Access Compliance Report

Public Rights-of-Way

(Pedestrian Signals)

Intersection ID: N/A	Main Street:	Cross Street: N/A	Location: N/A
ADA ID: 7DC0D4C6695B	Signal Type: One Push Button-Non APS	Overall Compliance: No	Severity Score: BTN 1: N/A BTN 2: N/A No BTN: N/A
Codes/Mitigation Info/Possible Solution		Field Measurements/Component Compliance

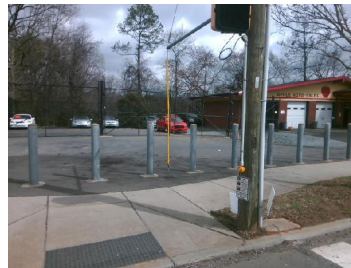
PROW/ADA: TMUTCD 4e.08, R404.7.2

N/A	B 1 Clear Xing Direction?	Yes	N/A	B 2 Clear Xing Direction?	N/A
	B 1 Crossing Direction	To SW		B 2 Crossing Direction	N/A
Yes	B 1 DistanceTo XWalk (in)	41.0	N/A	B 2 DistanceTo XWalk (in)	N/A
No	B 1 DistanceTo Curb (in)	9.0	N/A	B 2 DistanceTo Curb (in)	N/A
Yes	B 1 Diameter (in)	2.0	N/A	B 2 Diameter (in)	N/A

Possible Solutions: Replace Signal Push Button With APS Button on New Post. Remove & Relocate Sign.
